10/566,716

Makoto Saito

Office Action Summary	Application No. 10/566,716	Applicant(s) SAITO ET AL.	
	Examiner Jeffrey O'Brien	Art Unit 3677

Fig. 7

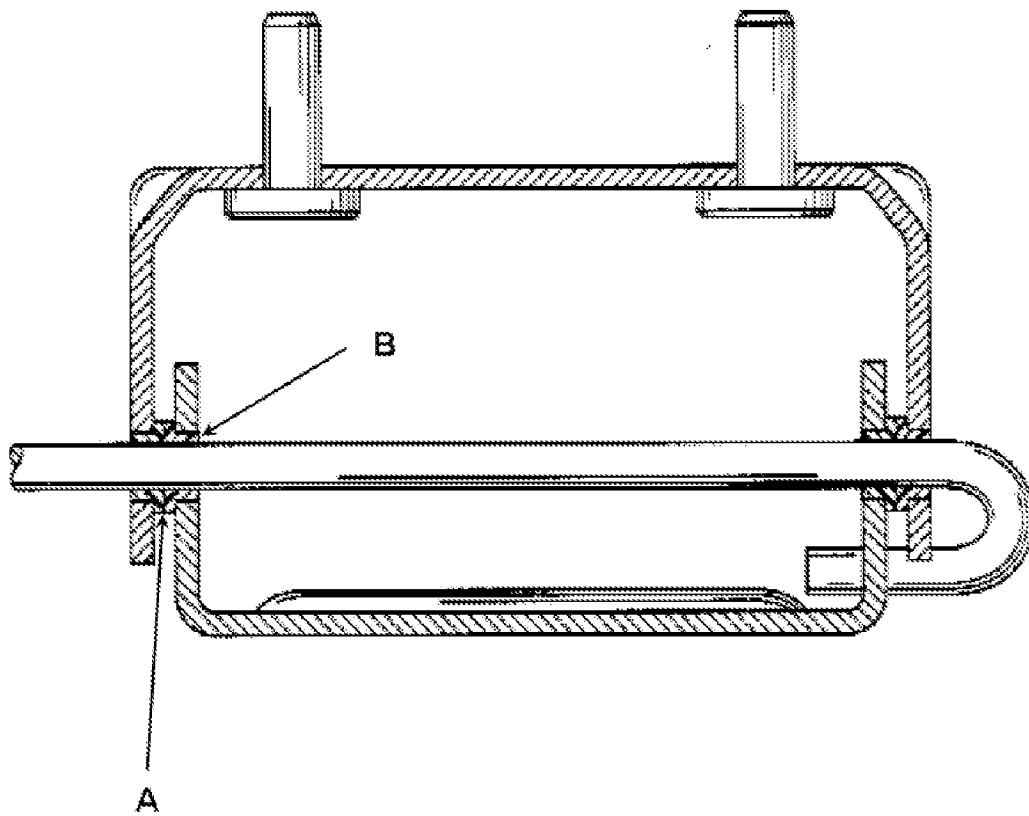
4. Claims 1-3, 5, 8 and 11 are rejected under 35 U.S.C. 102(b) as being anticipated by Duffy (US 6,619,723) herein referred to as '723.
5. For Claim 1, '723 discloses a hinge device comprising: a friction-force generating mechanism (annotated Fig. 7: A) that has a shaft (B) supporting--rotatably in both the forward and reverse directions--a rotation-side member (Fig. 1: 20) on a stationary-side member (46), and that uses friction force to hold the angle of the rotated rotation-side member, and a torsion bar (Fig 3: 60) that penetrates through said shaft in the axial direction in such a way that parts of said torsion bar are exposed outside both ends of said shaft (as seen in Fig. 7), with one end (80) of said torsion bar directly or indirectly fixed to said stationary-side member (46), and the other end (Fig. 4: 64) of said torsion bar directly or indirectly fixed to the rotation-side member (20), and that--by being

twisted by the rotation of the rotation-side member in either the forward or reverse direction--stores torque that energizes the rotation-side member in the direction opposite to said rotation of the rotation-side member.

7. For Claims 3 and 8, '723 discloses a hinge device as set forth in claims 1 and 2, wherein a stationary side hinge bracket (40), which is connected with said stationary side member (46), and a rotation side hinge bracket (26), which is connected with said rotation side member (20), are attached to said shaft (B), and said torsion bar penetrates through said stationary side and rotation side hinge brackets (as seen in Fig. 7).

8. For Claims 5 and 11, '723 discloses a hinge device as set forth in claims 3 and 4, wherein one end (64) of said torsion bar (60) is fixed to and engaged with either said stationary side hinge bracket (40) or said rotation side hinge bracket (26).
